Wardsboro BRF 013-1(15)

Conceptual Value Engineering Proposal

Wardsboro BRF 013-1 (15)
Estimate of Development Costs

PROJECT NAME: WARDSBORO	
PROJECT NUMBER: BRF 013-1(15)	
FILE NAME: s92b283sup.dgn	PLOT DATE: 15-JUL-2015
PROJECT LEADER: C. CARLSON	DRAWN BY: D. KARABEGOVIC
DESIGNED BY: D. PETERSON	CHECKED BY: D. PETERSON
DECK FRAMING PLAN	SHEET 26 OF 51

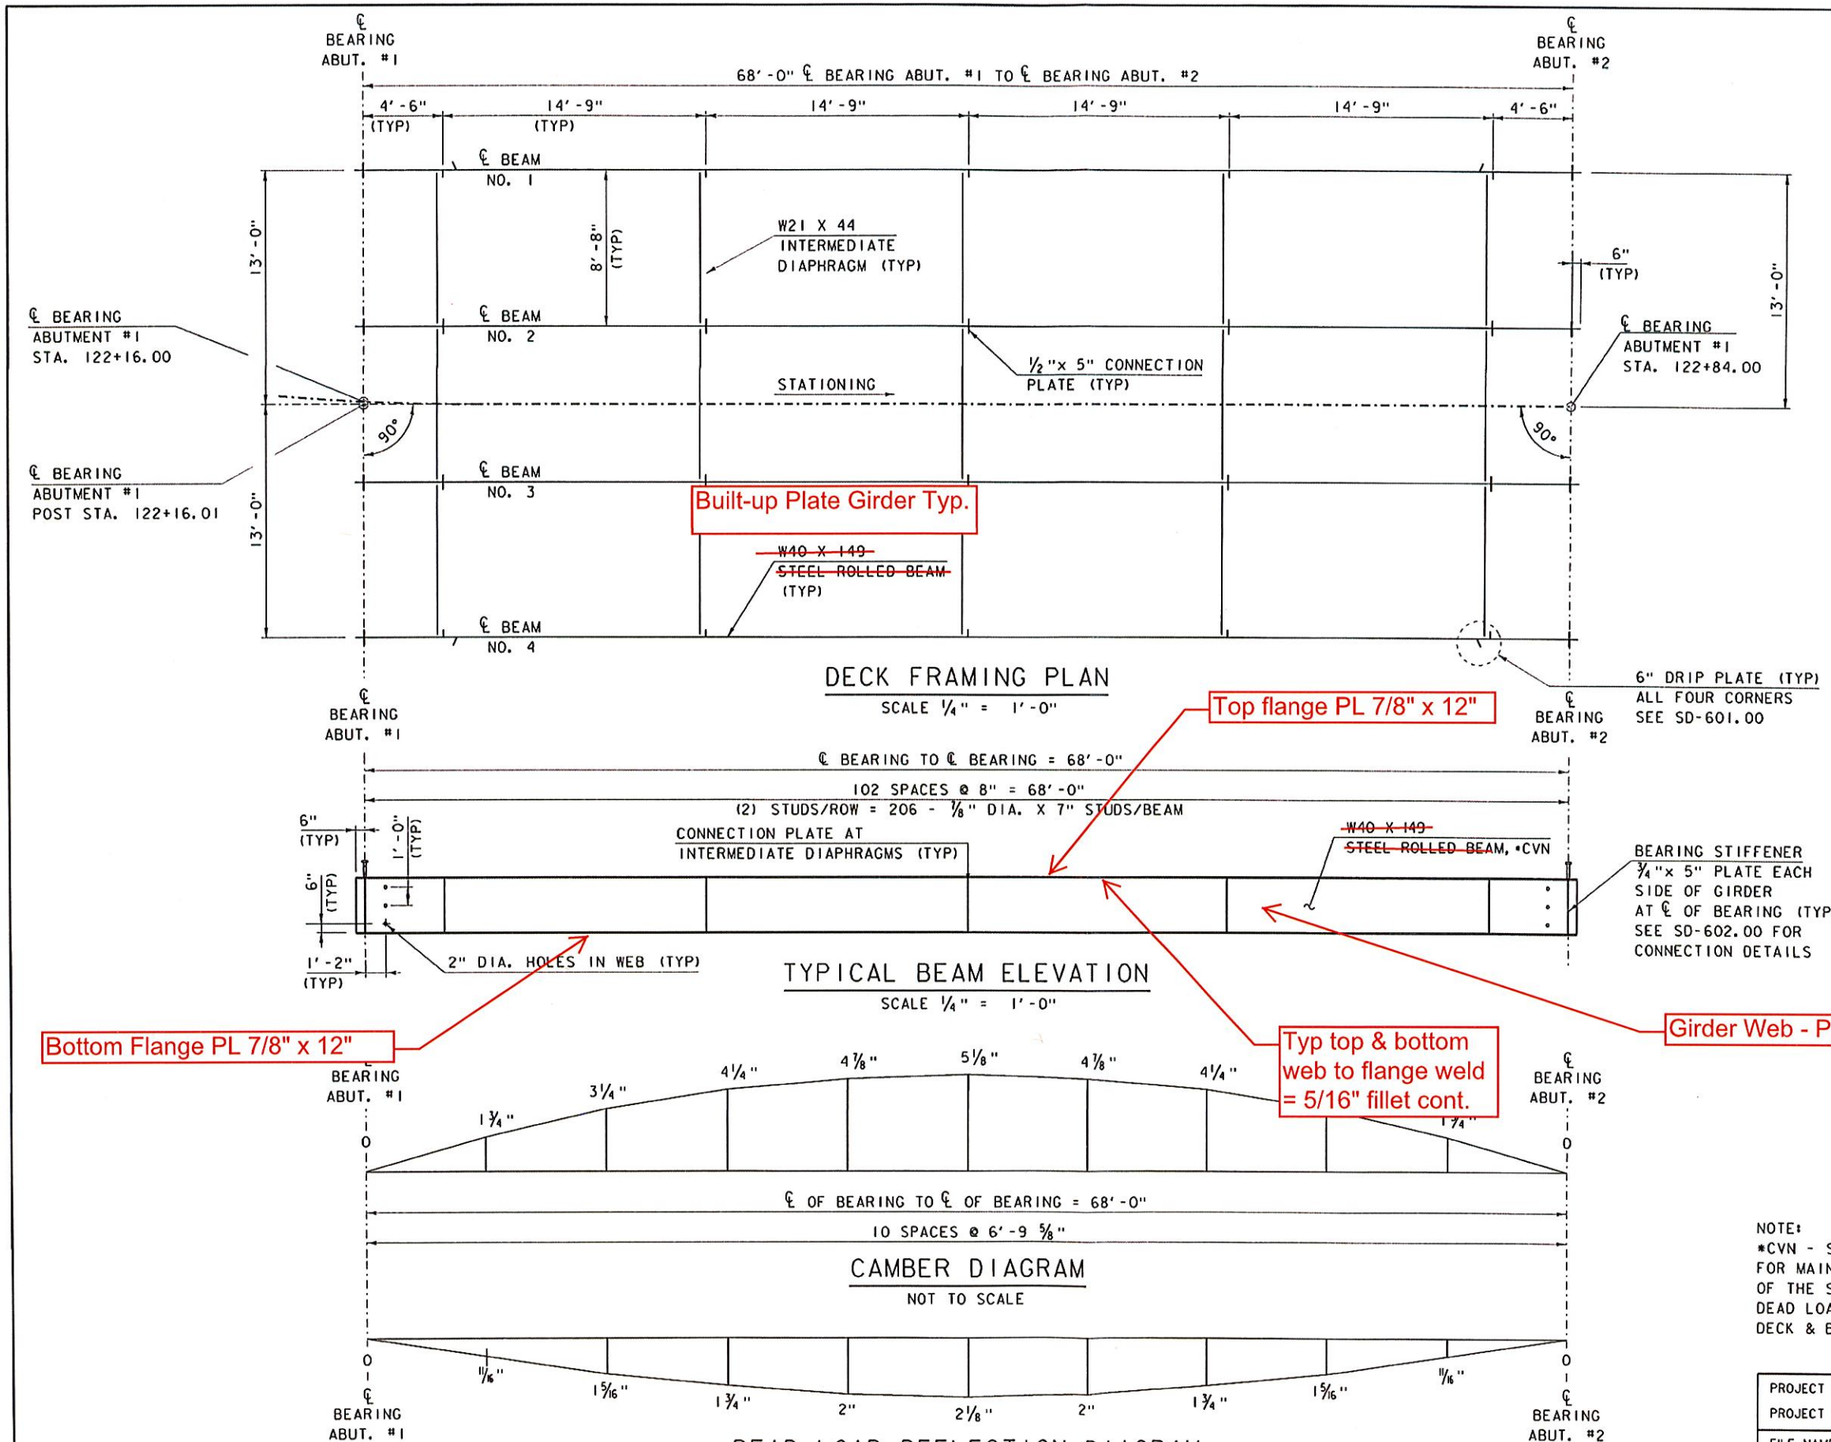
This conceptual value engineering proposal is to use built-up welded plate girders in lieu of the W40 x 149 Rolled Beams. We will utilize the plate sizes as shown on attached marked up Contract Sheet 26 and use a 5/16" fillet weld web to flange.

The W40 x 149's have a higher cost per pound for raw material as well as a higher cost per pound shop labor to induce the camber. Plate girders can have the camber burned right into the web which will produce a much better end product.
